File No. 180697

Board Item No. 50

COMMITTEE/BOARD OF SUPERVISORS

| <input type="checkbox"/> | <input checked="" type="checkbox"/> | <u>Planning Department Memo Response - July 23, 2018</u> |

Figure 1. (left) PM_{2.5} Thresholds and Maximum Project Impact. (right) Cancer Risk Thresholds and Maximum Project Impact.

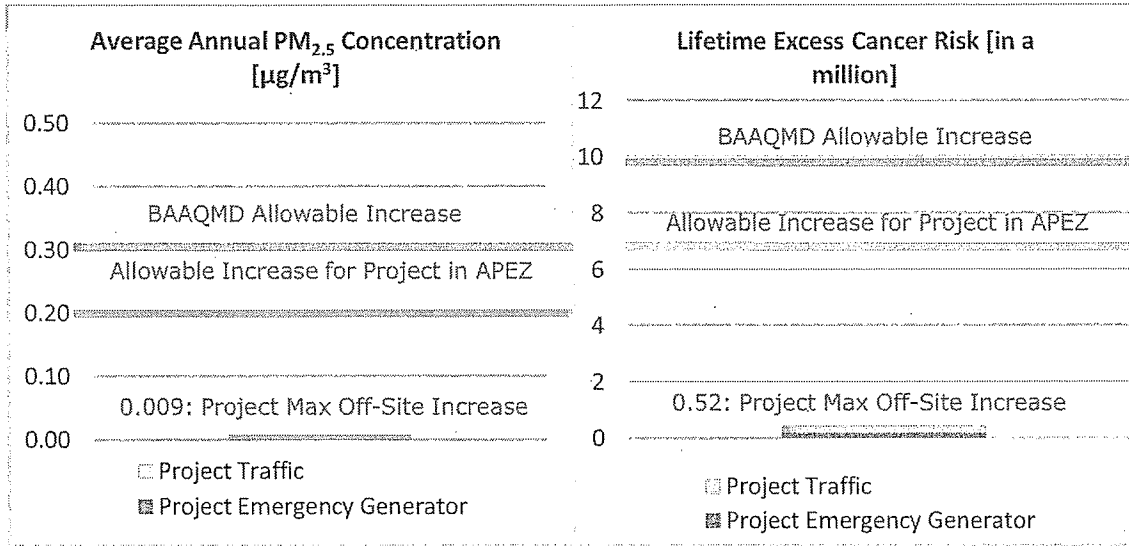
Analyses were conducted to determine whether the additional impact of the proposed Project emissions to off-site and on-site receptors would exceed these incremental thresholds. As shown in Tables 8 through 11 of the AQTR, the maximum cumulative cancer risk and PM_{2.5} concentrations from traffic plus emergency generator operations were 0.52 in a million and 0.0093 ug/m³, respectively. These maximum impacts are far below the thresholds and are therefore not considered to significantly impact health. Comparisons of the maximum Project impacts to the PM_{2.5} and cancer risk thresholds are shown in Figure 1.

Figure 2. CFD Modeling Results

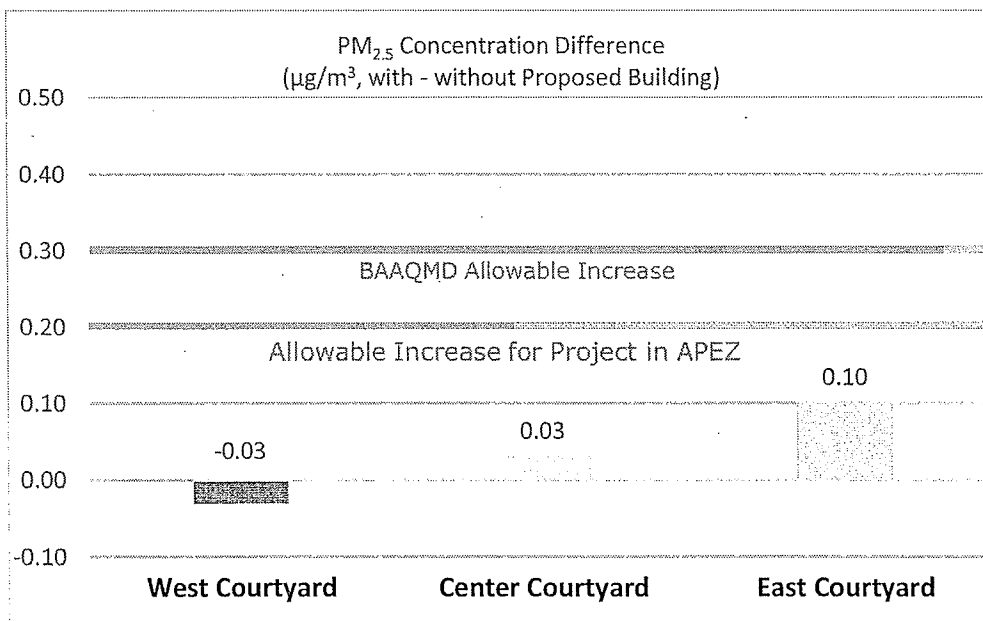
CFD modeling was performed to further visualize the potential impacts of the proposed building on existing traffic emissions dispersion in response to the 2009 CEQA appeal of a previous project on the project site. As shown in Table 13 of the AQTR, the maximum increase in PM_{2.5} concentration in any of the neighboring courtyards due to the building placement was 0.1 ug/m³. This increase would also be well below the threshold of 0.2 ug/m³, as shown in Figure 2.

Figure 1. (left) PM_{2.5} Thresholds and Maximum Project Impact. (right) Cancer Risk Thresholds and Maximum Project Impact.

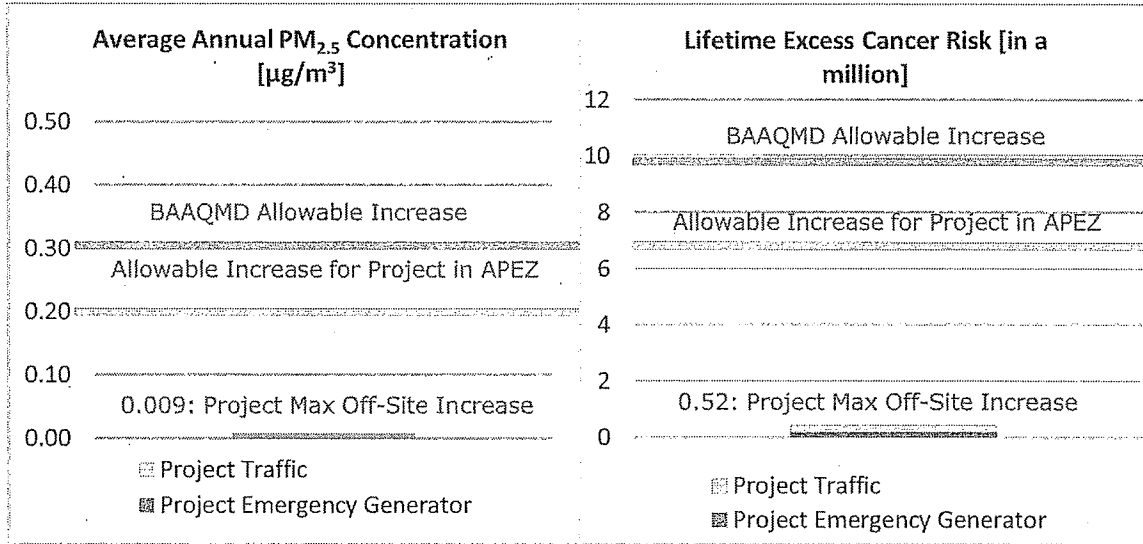
Analyses were conducted to determine whether the additional impact of the proposed Project emissions to off-site and on-site receptors would exceed these incremental thresholds. As shown in Tables 8 through 11 of the AQTR, the maximum cumulative cancer risk and PM_{2.5} concentrations from traffic plus emergency generator operations were 0.52 in a million and 0.0093 ug/m³, respectively. These maximum impacts are far below the thresholds and are therefore not considered to significantly impact health. Comparisons of the maximum Project impacts to the PM_{2.5} and cancer risk thresholds are shown in Figure 1.

Figure 2. CFD Modeling Results

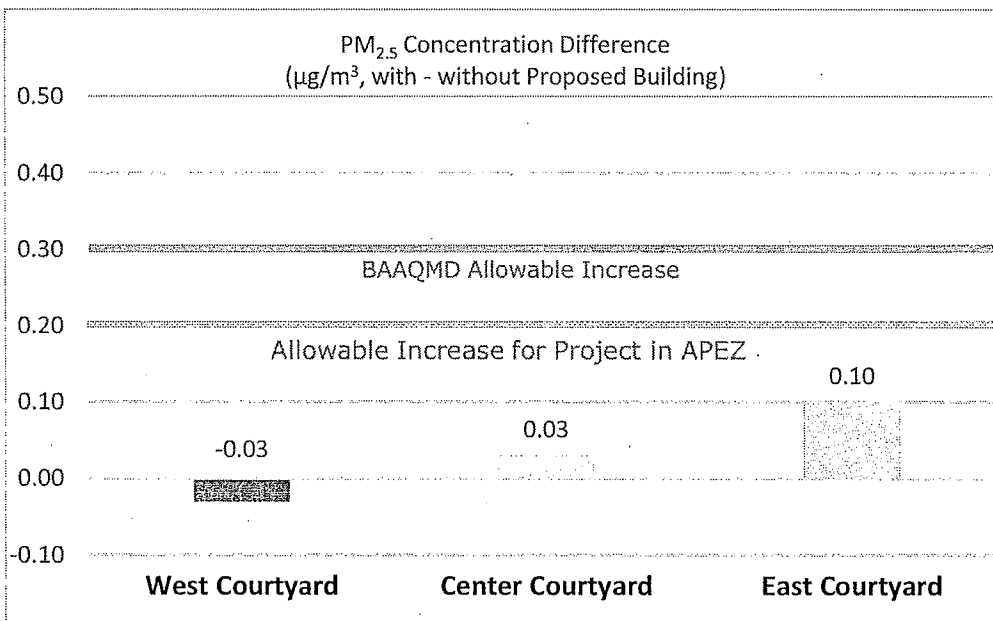
CFD modeling was performed to further visualize the potential impacts of the proposed building on existing traffic emissions dispersion in response to the 2009 CEQA appeal of a previous project on the project site. As shown in Table 13 of the AQTR, the maximum increase in PM_{2.5} concentration in any of the neighboring courtyards due to the building placement was 0.1 ug/m³. This increase would also be well below the threshold of 0.2 ug/m³, as shown in Figure 2.
